PUBLIC DRAFT

Groundwater Sustainability Plan

APRIL 2019

Figure 1-5 - Non-County Jurisdictional Boundaries

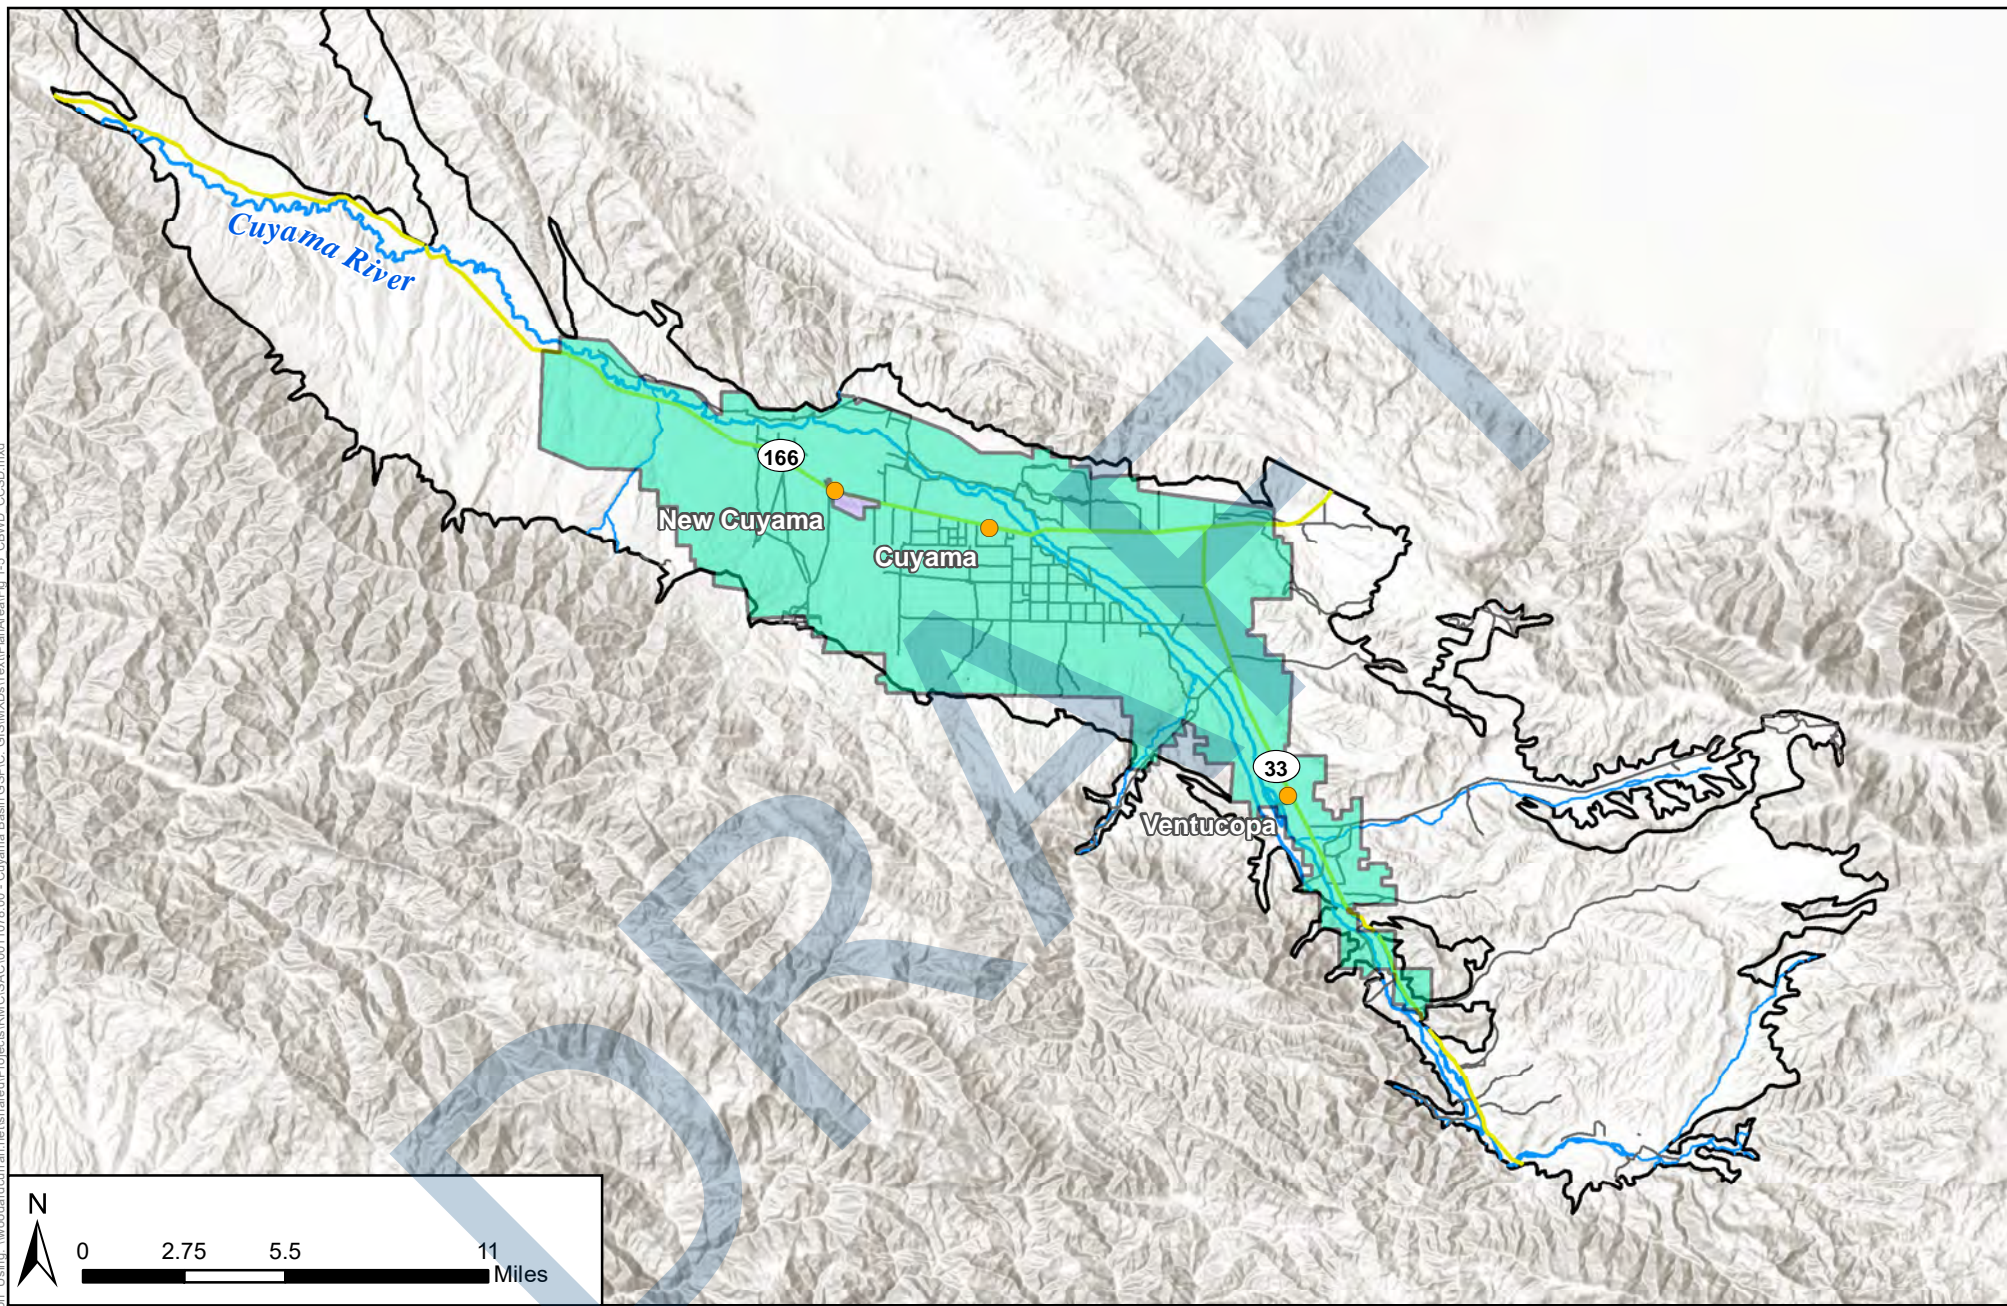
118	1.3			Figure 1-5	Comment: Figure 1-5 is at an unnecessarily odd scale and it would be helpful to see it combined with Figure 1-4 so as to see which county is responsible for the parts of the Basin which are outside of the Water District.	The scale of Figure 1-5 will be modified to show full basin. The Figures have been organized to clearly show compliance with SGMA requirements and therefore, the contents and numbering of each figure will not change.
119	1.3			Figures 1-6 and 1-7	Comment: Figures 1-6 & 1-7 regard land use changes up to 2014, however significant changes have happened across the valley with regards to land use and crop changes. How can the changes at Harvard Vineyard, Sunridge Nursery, Duncan Farm, Sunrise Olive, the Solar Farm and others be accounted for as they all are recent major land use changes on a large portion of the valley?	Land use for additional years, including 2016, is currently being processed and will be shown in the next revision of the Plan Area document. These land use datasets only show irrigated agricultural lands and therefore do not include non-irrigated range and pasture land. However, water use from these other land areas will be accounted for in the numerical model and water budget as part of the GSP.

Figure 2-8: Major Faults

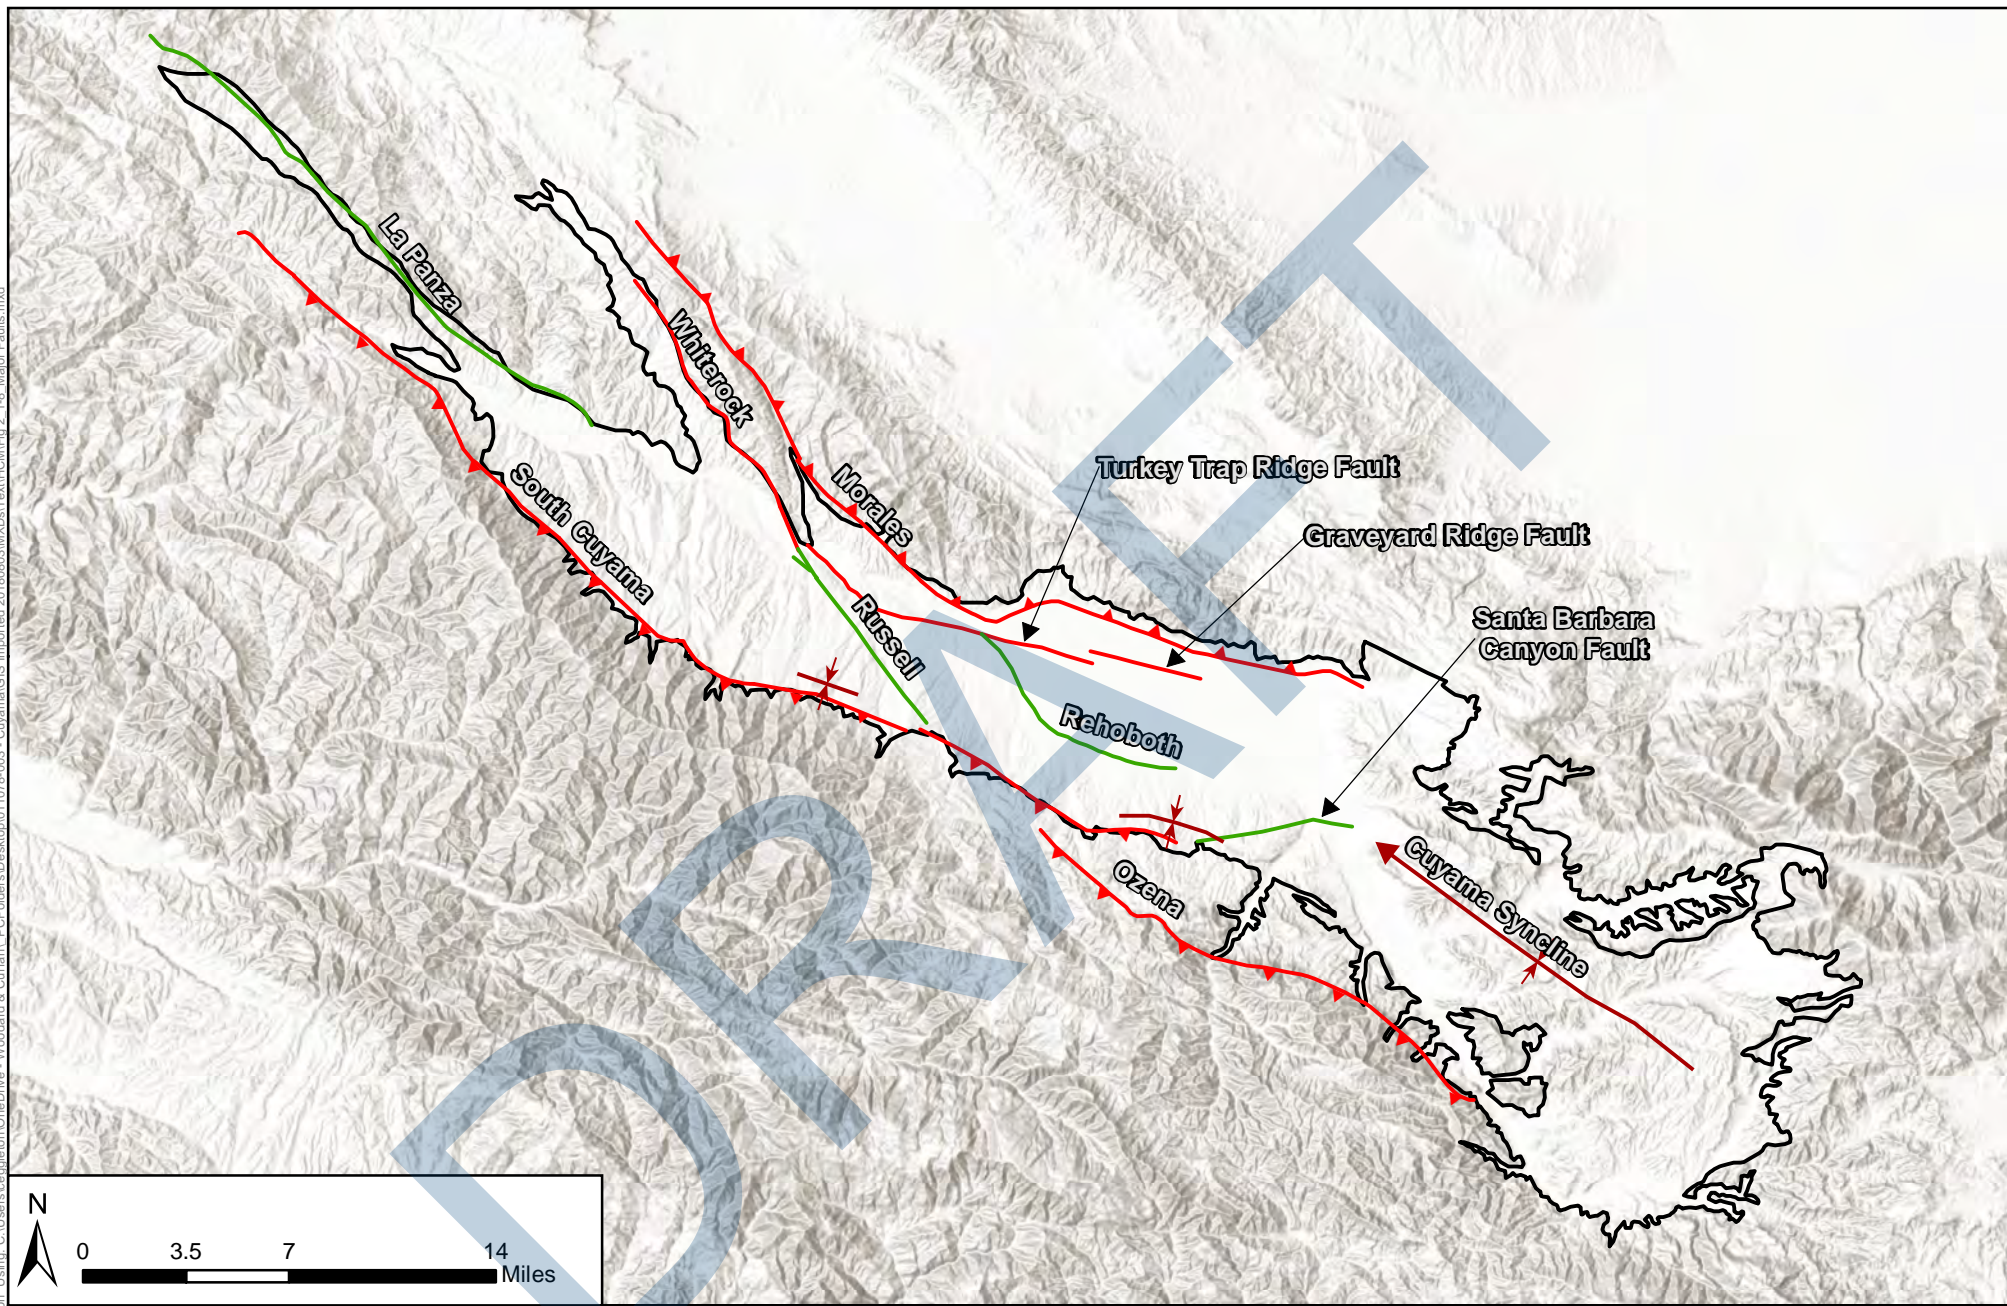
21	2.1.6	Figures 2-8 to 2-11			These cross sections need a legend and should trace the current & historic groundwater levels similar to the way the USGS did with their cross sections. The cross sections should also indicate where one intersects another and should show the locations of the major faults and synclines as they intersect these sections as shown in the USGS charts of the same cross sections. If these cross sections are from the USGS Study why are they redacted and without citations?	The cross sections have been updated.
22	2.1.7				No reference is made of the USGS GAMA reports and related sampling. No discussion of age dating, tritium isotopes, or trace metals. Can the historical data from Singer and Swarzenski (1970) be compared to the more current data by Hanson et al (2013) as part of the USGS Cuyama studies and the GAMA project to provide the relevant water quality trends? Why is the age dating data ignored as it relates to poor water quality and the lack of recent recharge?	Additional discussion of water quality (including historical water quality and age dating) is discussed in the Groundwater Conditions section.

78	2.1.6	Figures 2-9 to 2-11			Figures 2-9 through 2-11 need a legend, showing what formation each unit represents.	These cross sections have been removed. Revised versions will be included in a later draft.
79	2.1.8	3	5	Peak flows through the Cuyama River	Reference to peak flows. What gage and where is it? Upstream Ventucopa gage (period of record?) or downstream Buckhorn gage 15+ miles outside of the basin?	Gages were shown in the Plan Area section and more surface water data will be part of the Water Budget Section.
80	2.1.4	Global			This looks very good to me. I applaud the choice to verify fault barriers to water flow by well monitoring and not to rely on theoretical modelling of the geology. The modelling that has been done is understandably biased by the interests of a major user who has also employed two of the consultant firms listed as having modelled these faults and their impacts. This needs to be publicly disclosed in the interest of transparency.	Noted. No change needed to HCM.
